SIB 11 06 21

ROCKER ARM REPLACEMENT GUIDELINES

This Service Information Bulletin replaces measure 64011504-05 dated August 2019.

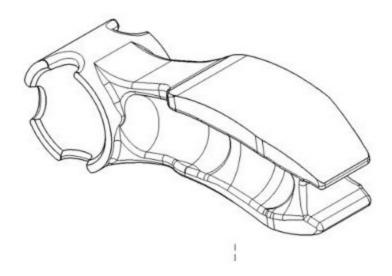
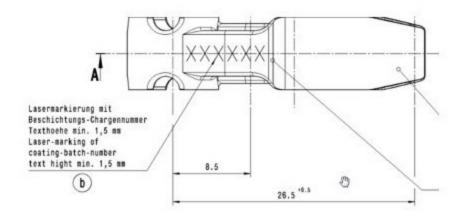
A redesigned rocker arm has replaced the older version in production motorcycles, as pictured below.

- New rocker arms

Current rocker arms

If ticking noises are caused by rocker arm wear, ALL rocker arms and damaged camshafts must be replaced, including in the opposite cylinder head on boxer engines. An oil change must also be completed after the repair.

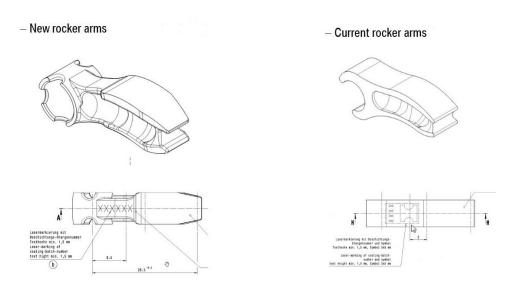
A redesigned rocker arm has replaced the older version in production motorcycles, as pictured below.

If ticking noises are caused by rocker arm wear, ALL rocker arms and damaged camshafts must be replaced, including in the opposite cylinder head on boxer engines. An oil change must also be completed after the repair.
